NLS2006038
May 30, 2006

Subject: Relief Request RI-06, Revision 3, for the Third Ten-Year ISI Interval
Cooper Nuclear Station, Docket No. 50-298, DPR-46

RELIEF REQUEST NUMBER: RI-06, REVISION 3**COMPONENT IDENTIFICATION**

Figure RI-06
HMC-BB-1 Scan Area
(Cross Hatching Represents Scan Limitation Areas)

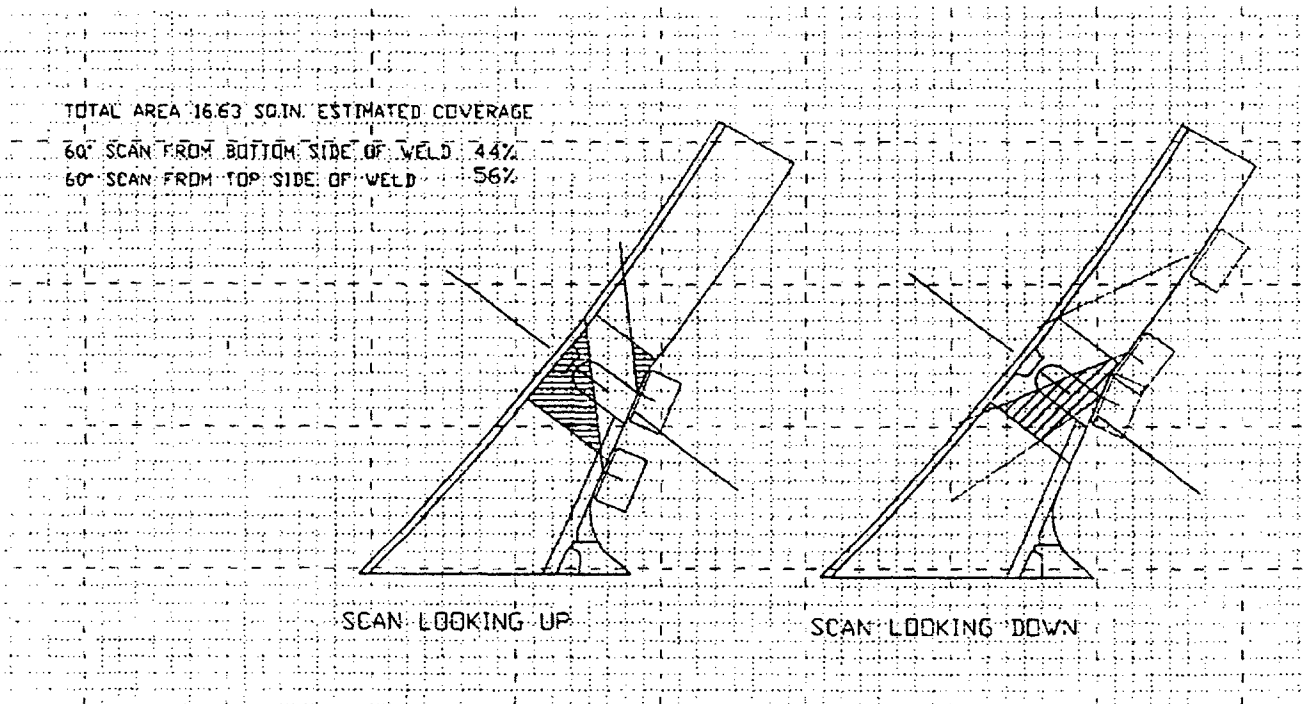
Proposed Relief Request RI-06, Revision 3, is a request to change the NRC allowable examination coverage in lower reactor vessel circumferential weld HMC-BB-1 from 86% total composite coverage to 75% coverage. The only weld affected by this relief request revision is HMC-BB-1. All other welds listed in this request met the NRC allowable examination coverage for the third ten-year interval and are not affected by this revision.

In addition to the physical limitation due to the proximity of the weld to the vessel skirt, the reduction in total composite coverage (i.e., 75% as opposed to previous 86%) is believed to be due to differences in procedure and equipment qualifications through the Performance Demonstration Initiative (PDI) as compared to previous requirements. Limitations of qualified transducer sizes through PDI contributed to the reduction of coverage compared to the previous examination of HMC-BB-1. This weld was examined in 1993 and again in 1995 using 0-, 45-, and 60-degree transducers. In 2001, the examination for the third interval was performed in accordance with ASME Section XI, 1995 Edition, 1996 Addenda, Appendix VIII, using only a 60-degree transducer. This examination achieved 75% total composite coverage. (See Figure RI-06, "HMC-BB-1 Scan Area.") However, based on the demonstrated qualification of the examiners, a more reliable examination was performed even though less coverage was achieved.

Since 10 CFR 50.55a requires the use of ASME XI Appendix VIII in detecting flaws in the welds at CNS, only qualified PDI procedures and specific qualified transducers may be used for the examinations. Previous examinations on the weld may have reported additional coverage, but since the previous examiners and equipment were not qualified by PDI, the 86% coverage reported during the second interval cannot be considered as reliable as the 75% achieved in the third interval. The PDI examination methods maximize the coverage that can be "reliably" obtained, even though PDI-qualified transducers and associated procedures limit how much coverage an examiner is able to achieve.

The CRD and instrument penetrations prevent direct access to most of the bottom head. Circumferential weld HMD-BB-1 is located inside the skirt and is inaccessible for examination. Portions of the Bottom Head Meridional welds, HMB-BB-1, HMB-BB-2, HMB-BB-3, HMB-BB-4, HMB-BB-5, HMB-BB-6 are located inside the vessel skirt and are inaccessible for examination. Access to weld HMC-BB-1 is limited due to the proximity of the vessel skirt. The configuration limits scanning with the 60 degree probe. The total composite coverage achieved for HMC-BB-1 in the third ISI inspection interval was 75% with no recordable indications.
